SUBJECT: 25-040 Loaf Land Subdivision - Comment Response

Thank you for your review of the Subdivision Application Permit (SP 4103) for Loaf Land Subdivision in Coplin Plt.. The team recently received review comments from LUPC in regard to this application, dated July 1, 2026. These comments can be seen below in *italic*, followed by Main-Land's response in regular typeset. For the reviewer's ease, we have provided a new printed and PDF copy of the application with the additional and/or updated materials associated with this submission.

UNDERDRAIN BEDDING

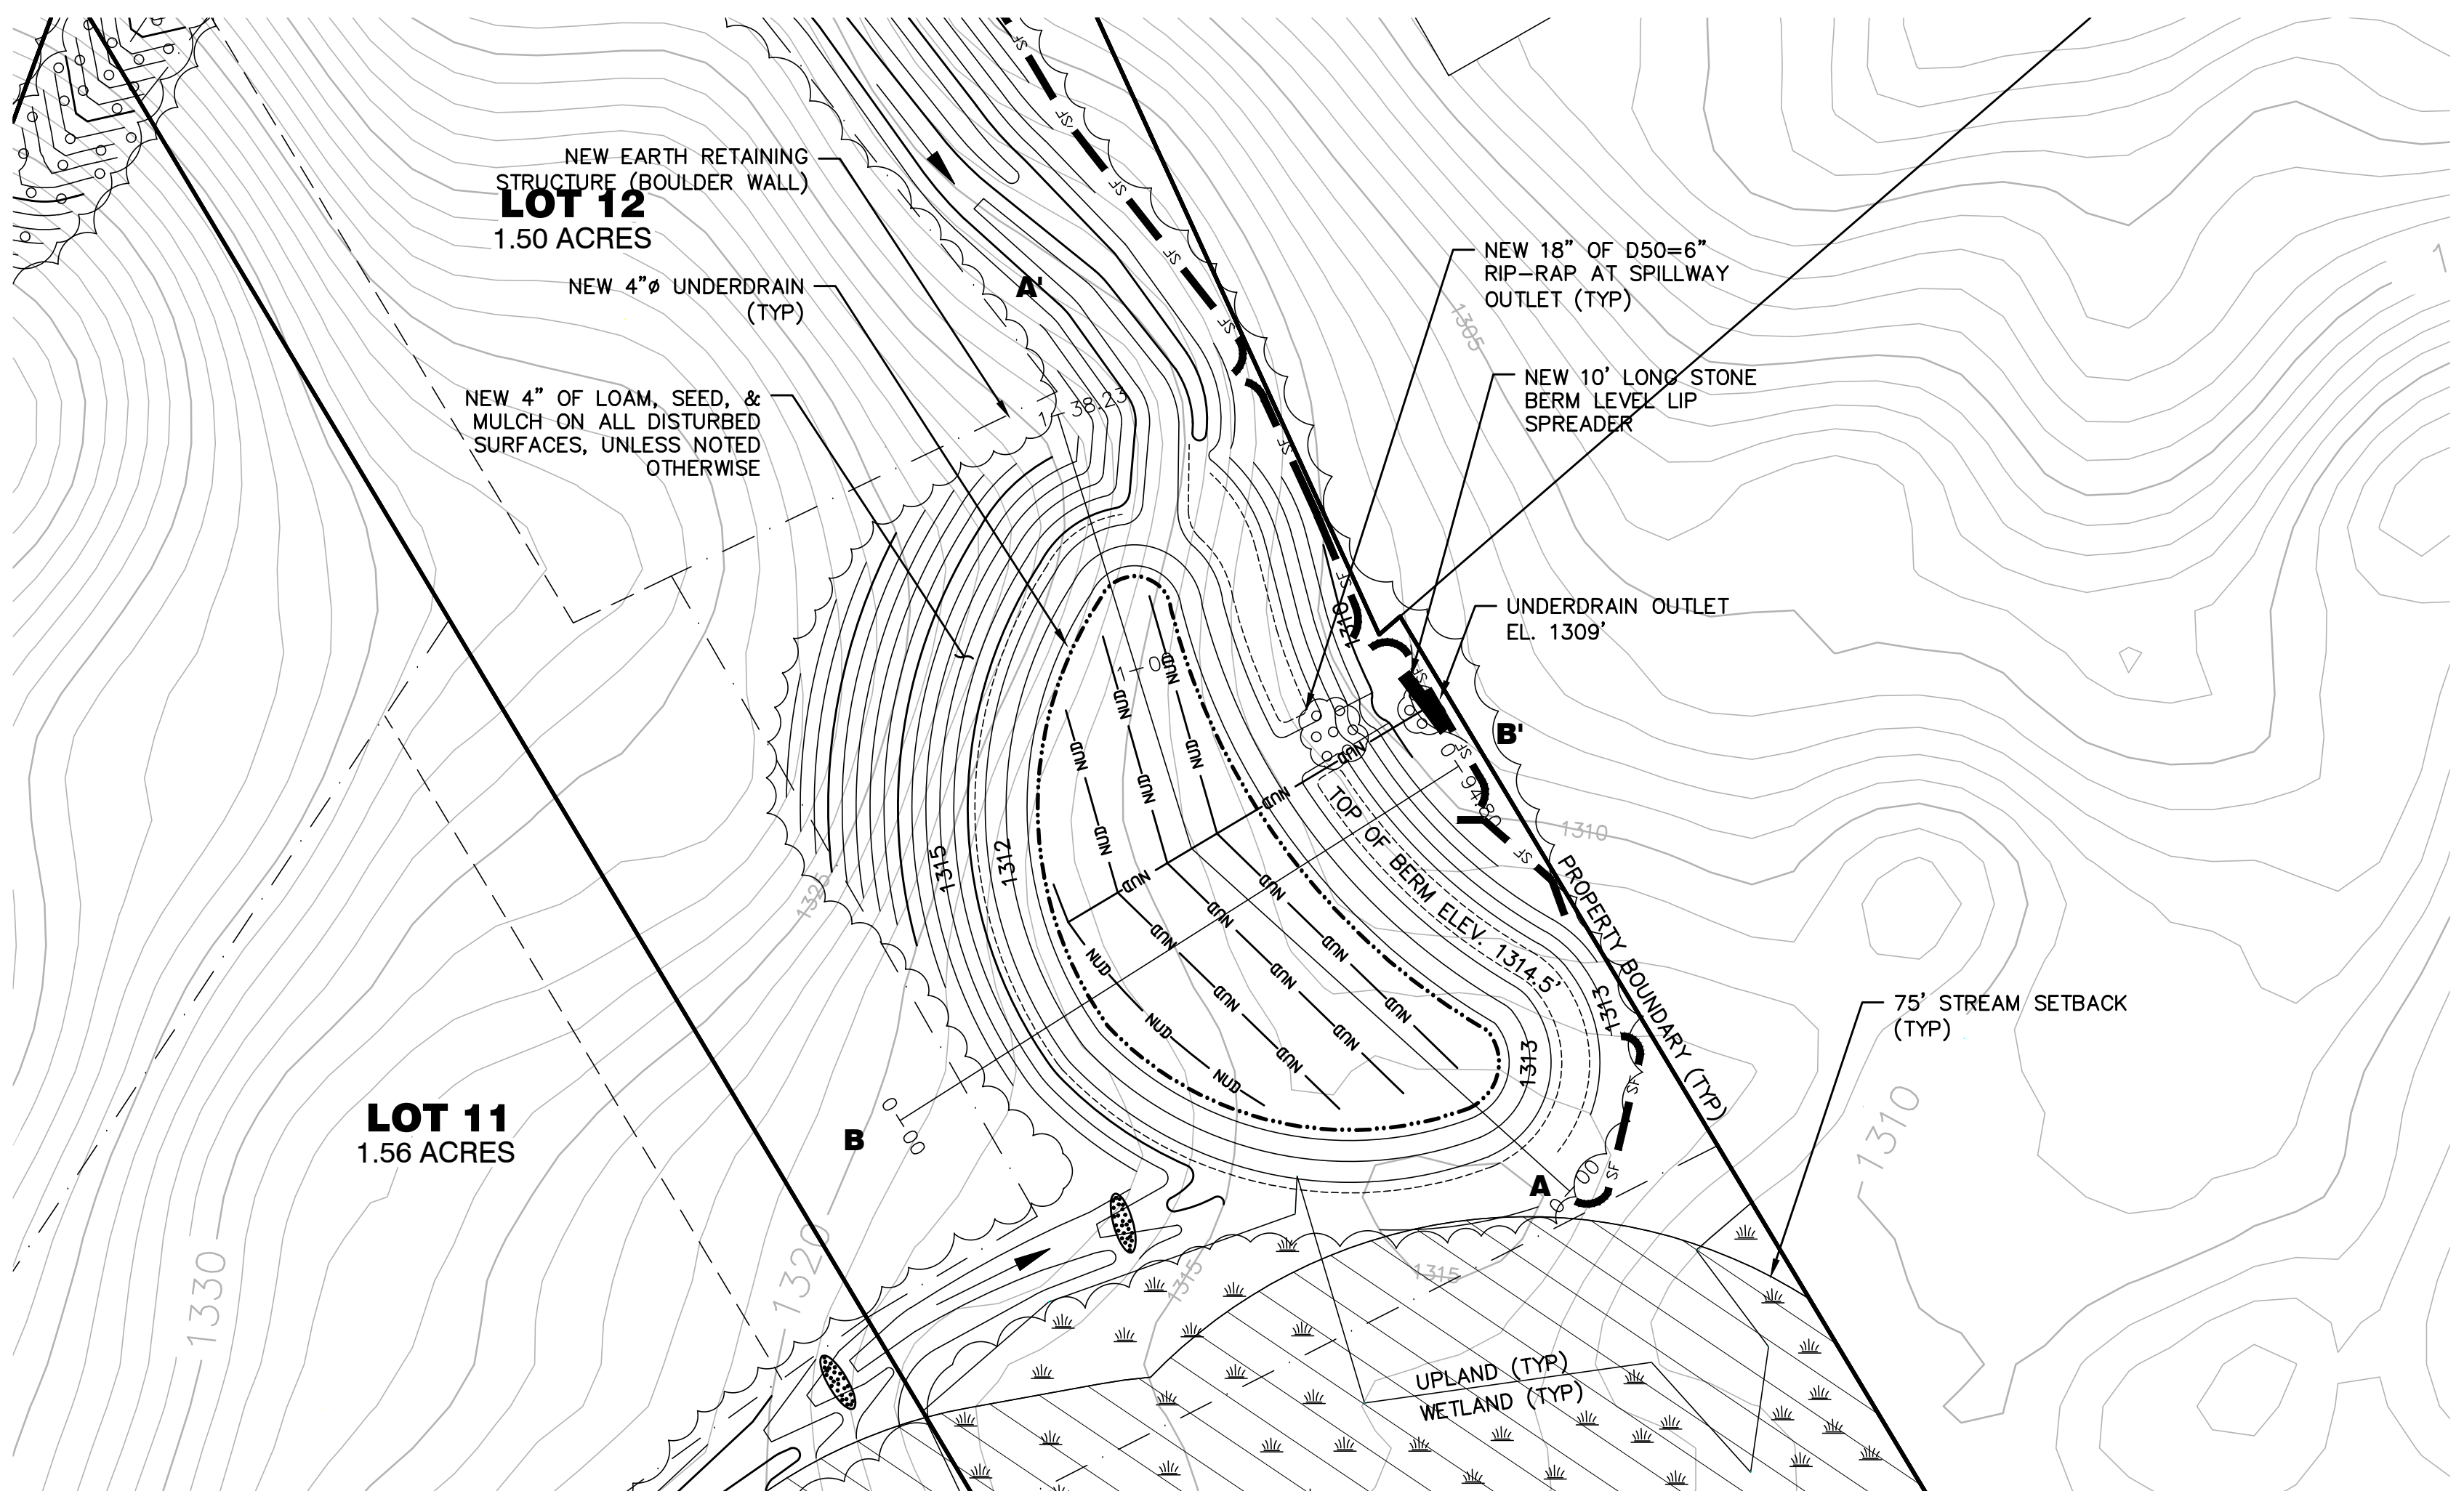
o *Sheet C6.2 – Filter Pond 2 Plan and Profiles*

▪ *Address comment IV.5 in the review by Sebago Technics*

IV. 5. The plan for Filter Pond 2 indicates the need for an uphill retaining wall or a boulder wall. The design team should provide details of the proposed retaining wall.

Since the treatment factor for Filter Pond 2 has been set to 0.25, the pond size was able to be slightly reduced. Because of this, the need for a retaining/boulder wall has been eliminated. This update is reflected in the revised plan set.
